SERVICE BULLETIN

APPLICABILITY: 2019MY Forester

NUMBER: 12-269-19

SUBJECT: Rattle Sound from EyeSight Camera Cover-
Design Change

New Part	Old Part
Lens Opening		
Rib Shape

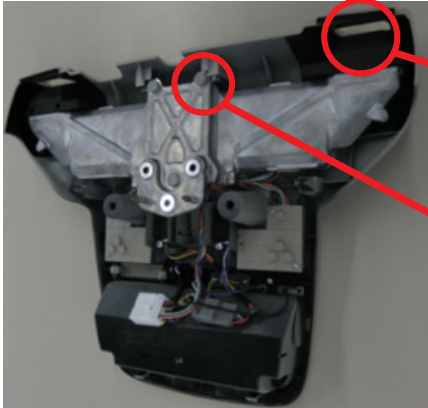
This bulletin announces 2 design changes to the EyeSight camera cover to prevent a rattling sound heard while driving. The changes involve the inside support ribbing near the front, center and a slight revision to the size of the bottom camera lens openings. Comparison images are provided below.

The new covers were incorporated into production starting with VIN **KH551044**.
